Official Transcript of Proceedings
NUCLEAR REGULATORY COMMISSION

Title: Advisory Committee on Reactors Safeguards
Open Session

Date: Wednesday, July 11, 2018

Interim Staff Guidance-06, "Licensing
Process" Draft Revision 2, and
Integrated Action Plan for Modernization
of the NRC's Digital I&C Regulatory Structure
Staff Presentation 41

ACRS Subcommittee Comments

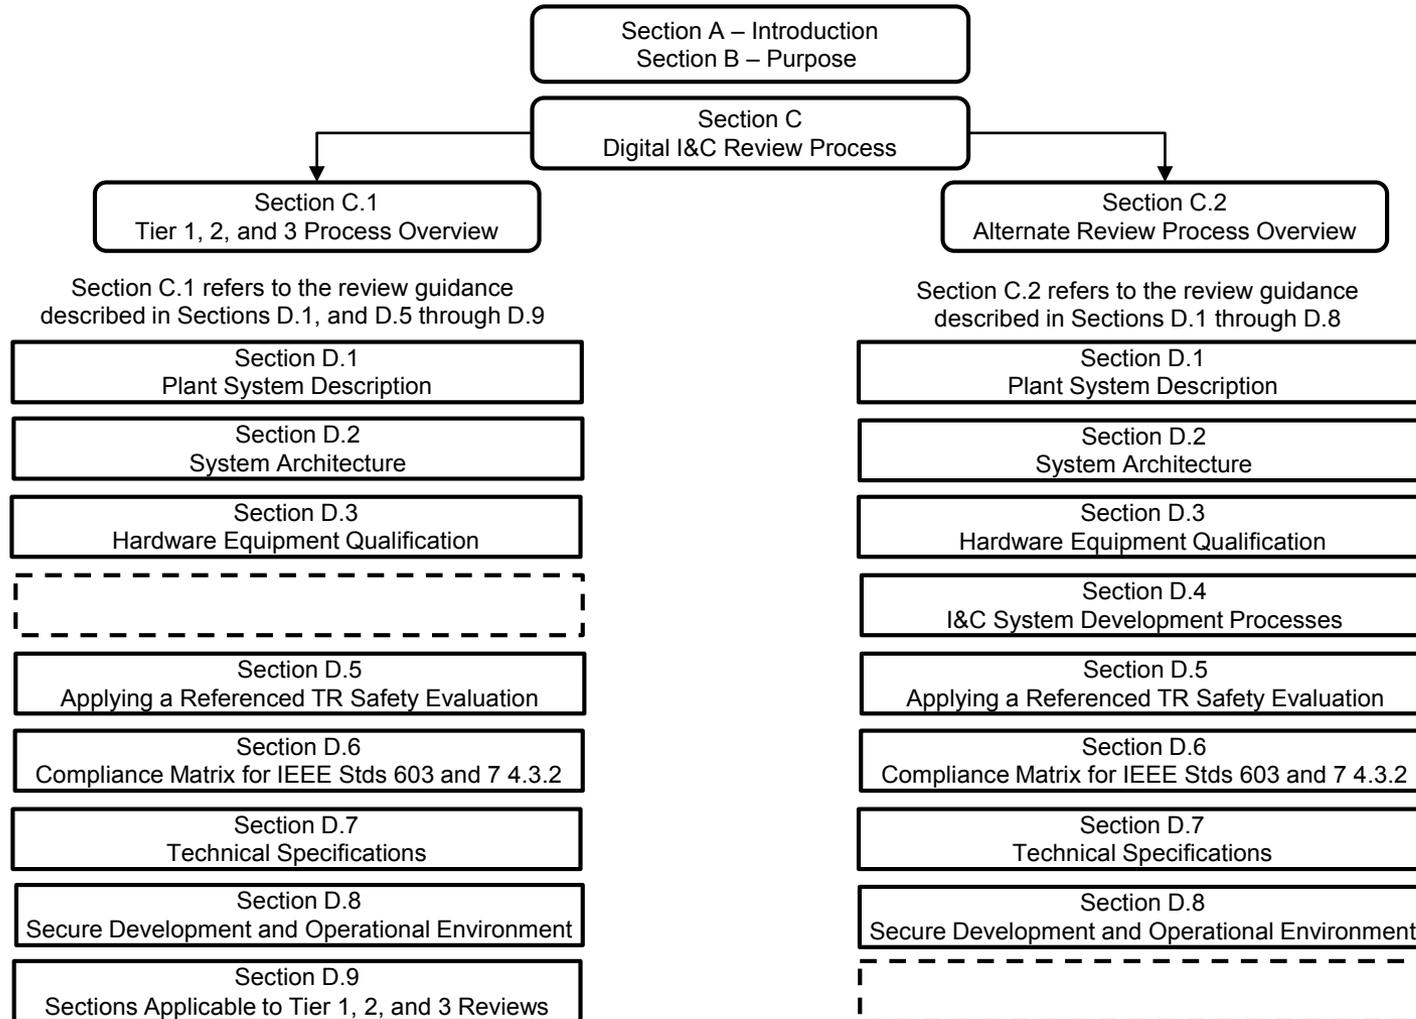
- System Architecture – the ISG doesn't show how System Architecture is covered/reviewed under the Tier 1, 2 and 3 Review Process.
 - Section D.2, “System Architecture,” will now be applicable to both processes, and Enclosure B, “LAR Submittal Information” has been updated accordingly.
- Four Fundamental Design Principles – it is not clear how the four fundamental design principles are applied to a Tier 1, 2 and 3 Review
 - Section D.2, which contains the sections on the fundamental design principles, is now applicable to both Processes.

- Hardware Configuration Control – the ISG is silent in regards to configuration control and configuration management of hardware.
 - The staff is evaluating how to address this concern in the ISG

11 So, what we've done since that meeting,
12 and since we submitted this slide, is we scrubbed the
13 ISG. We looked when we talk about configuration
14 management, and we had a section D.4.2.5. It used to
15 be titled, "Software Configuration Management
16 Process". We looked at it. We realized we don't need
17 to exclude hardware. So, right now, it's just
18 "Configuration Management Process". Whenever we've
19 talked about configuration management, and we've
20 focused on software, we realized that there's no need
21 to just exclude it. So, one of the fixes was to
22 remove the word "software"; just make it generic.

17 We tried to change the language in the ISG
18 so hardware wasn't excluded. We did not create or add
19 or reference any other hardware-specific configuration
20 management documents because I don't think we use any.
21 So, that's how we tried to address that particular
22 comment.
